ASSESSMENT REPORT for Modification Proposal P213 'Facilitating microgeneration (Optional Single MPAN)'

Prepared by: P213 Modification Group

Date of Issue: 9 August 2007
Reason for Issue: For Use

Document Reference: P213AR
Version Number: 1.0

No Export to P213 1 MPAN to 1 MPAN (1 meter) Change of Supplier (CoS: Old Supplier S1; New Supplier S2)

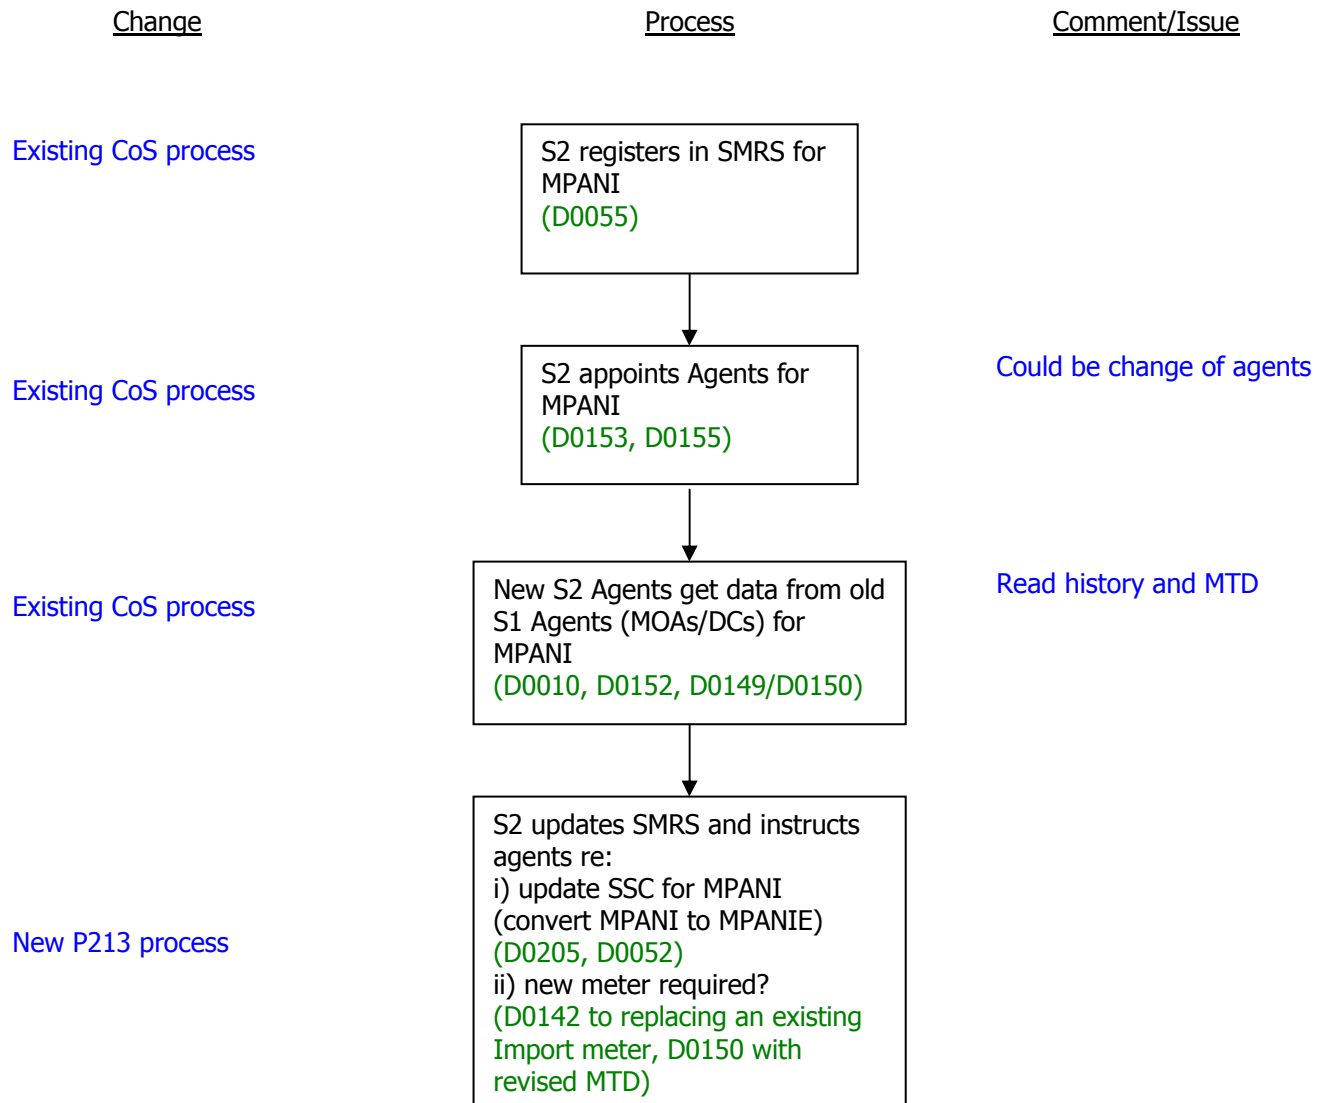
No meter issues for CoS.
Potential issues when convert a MPANI to MPANIE

P213 to no Export 1 MPAN to 1 MPAN (1 meter) Change of Supplier (CoS: Old Supplier S1; New Supplier S2)

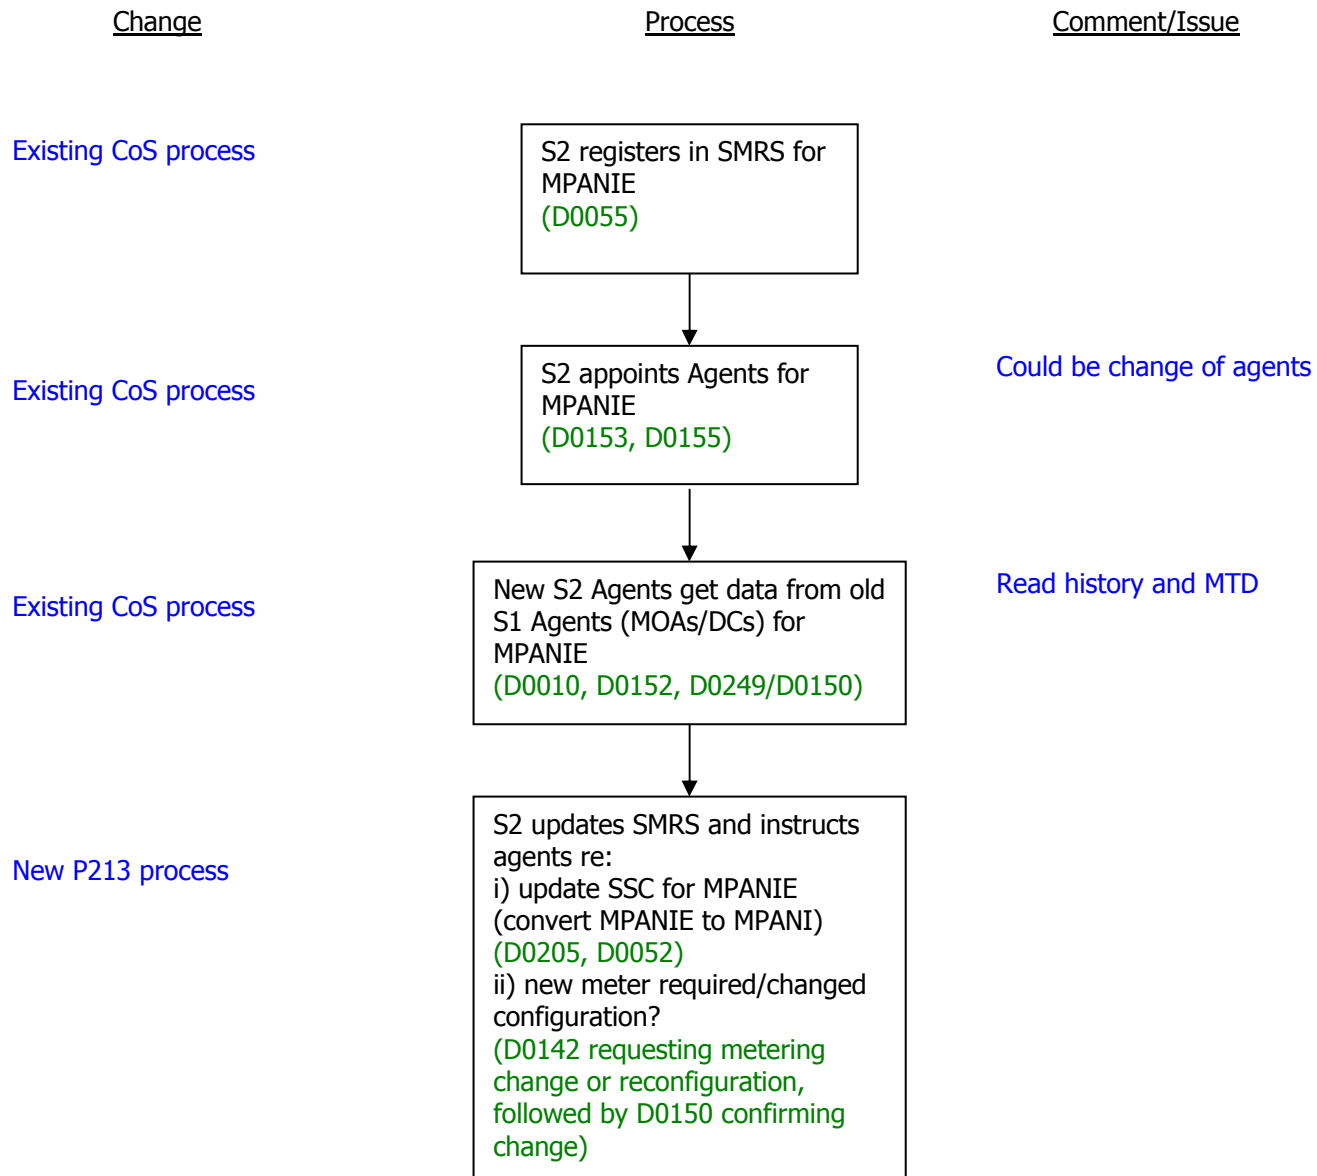
There may be ongoing problems for MOA/DC with redundant registers. Agents need to be aware of registers not used for Settlement purposes.
They may be issues for Old Supplier closing off export readings.
